MANDATORY SERVICE BULLETIN

NUMBER: SB-020
REVISION: A
DATE: 10/16/2009

SUBJECT: FUSELAGE; MISSING FASTENERS

Figure 1: No Fasteners

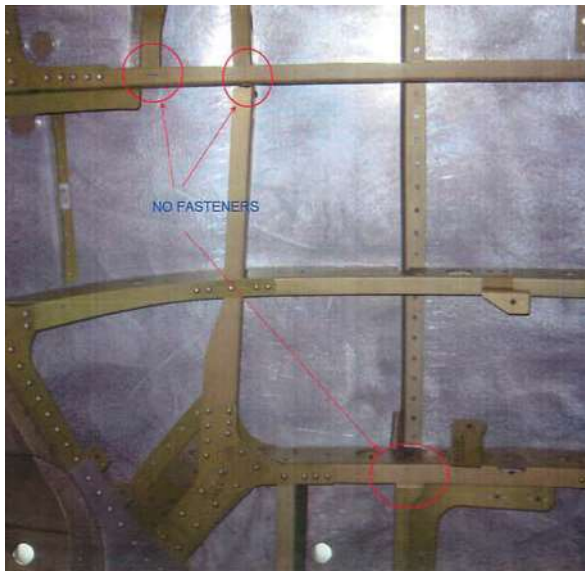
Quest is mandating a one-time inspection of the ceiling in the forward cabin. The inspection is to identify whether 6 fasteners are present in the forward cabin. If the fasteners are present, no action is needed. If the fasteners are not present, the fasteners will need to be installed following the directions contained in this Service Notification.

Task	Instruction
<p>4</p>	<p>Install fasteners (P/N CR3213-5) in the four AFT locations and fasteners (P/N CR3213-4) in the two FWD locations indicated in Figure 1. For fasteners (P/N CR3213-5) hole diameter must be dimensioned at 0.159 - 0.164 with a minimum edge distance of .300. For fasteners (P/N CR3213-4) hole diameter must be dimensioned at 0.129 - 0.134 with a minimum edge distance of .250. Figure 4 and Figure 5 illustrate the completed installation.</p> <p>Note: Fasteners shown in Figure 5 are Solid Rivets.</p> <div data-bbox="711 199 1469 940"> <p>Fastener (P/N CR3213-4)</p> <p>Figure 4</p> <p>Will be Fasteners (P/N CR3213-5)</p> <p>Figure 5</p> </div>
